July 20, 2018

RE: Request by Google LLC for Waiver of Section 15.255(c)(3) of the Commission's Rules, ET Docket No. 18-70

Coexistence Simulation between SRD and Google Soli

Facebook, Inc.

SRD blocking (CCA triggered)

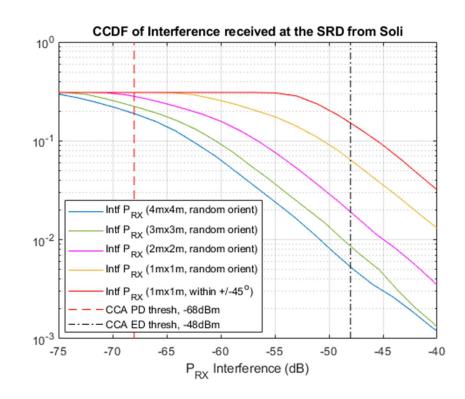
- Soli performs a single frequency sweep of several CW tones across the 7GHz bandwidth in 600us [2]
- Since the 600us is significantly larger than a 802.11ad slot time (5us), only tone generated within the SRDs bandwidth (2.16GHz) is assumed to block the SRD by triggering its CCA.

- When the CW sweep instantaneously lies outside the SRDs bandwidth it is assumed that the CCA is not triggered. This provides a 70% reduction in blocking if SRD only use single carrier.

- The CCDF of the Interference received at the SRD after accounting for the bandwidth sweep is shown here, and it can be seen that the SRD is blocked
 - in 20% of the cases if Preamble Detection (PD) threshold is used.

- But since Soli signals are non-11ad signals the Energy Detection (ED) thresholds should be used, which keeps the probability of blocking at around 0.5% for 4x4m room.

- At closer proximities (smaller room dimensions) it can be seen that the blocking probability increases rapidly.
- If the Soli device is on the same person using the SRD device, then it can be assumed that the Soli TX and SRD RX are within +/-45 of each other. In this case the blocking probability can be as high as 15%.

- Based on the ED threshold an SRD is blocked by Soli only if its within 0.6m from the Soli device.
- If 11ay SRD is used, performance may be twice worse than this.

C/I at SRD

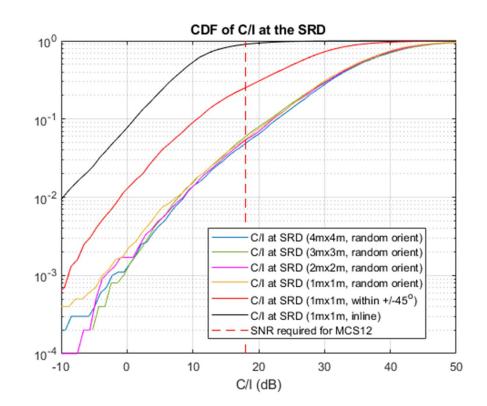
- The plot shows the C/I at the SRD in presence of a Soli device in the same room.
- MCS12 (16QAM ¾) requires 18dB of SNR for detection with 1% PER.
- Probability of achieving MCS12 is around 95%, irrespective of room size as both interference as well as signal increases.
- However, in the case both devices are on the same person (i.e. devices within +/-45 degree of each other), then the C/I degrades, only in 75% cases will the SRD attain MCS12.
- In the worst case when both links are inline with each other, the probability of attaining MCS12 is ~10%, which is not acceptable.
- Note that this plot assumes a 25dBm EIRP from the SRD device, however if TX power backoff is required, then the curve moves left by the amount of backoff in dBs.
 - Typically, a 4-5dB backoff is applied when transmitting 16QAM, which would degrade the probability of achieving MCS12.
